# Service Information

SI0283

Equipment Affected: YK with OptiView Control Panel

V.26 YK OptiView Chiller Control Panel

LD18178

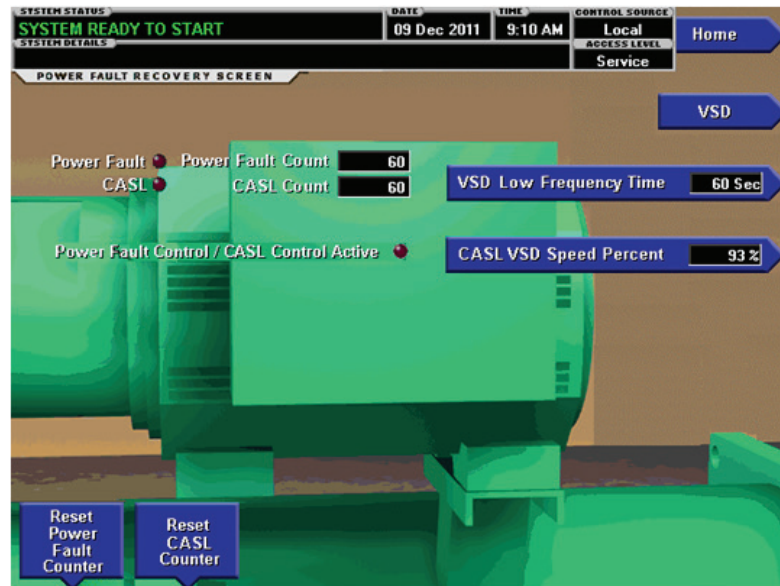
A Power Fault Recovery screen has been added that is accessible from the MVVSD screen and provides Power Fault Recovery Control indication and configuration.

The following settings are displayed on the Power Fault Recovery Screen:

PROGRAM SETTING	SCREEN	MODE	LOW LIMIT	HIGH LIMIT	DEFAULT
VSD Low Frequency Fault Time	Power Fault Recovery - Button 8	*	60 sec	120 sec	60 sec
CASL VSD Speed Percentage	Power Fault Recovery - Button 9	*	80%	100%	93%

The VSD Low Frequency Fault Time will adjust the amount of time that the VSD speed can be below the minimum speed. When Power Fault Recovery Control is not enabled, this setting will have no affect and the Low Frequency Fault will be the standard time of 25 seconds.
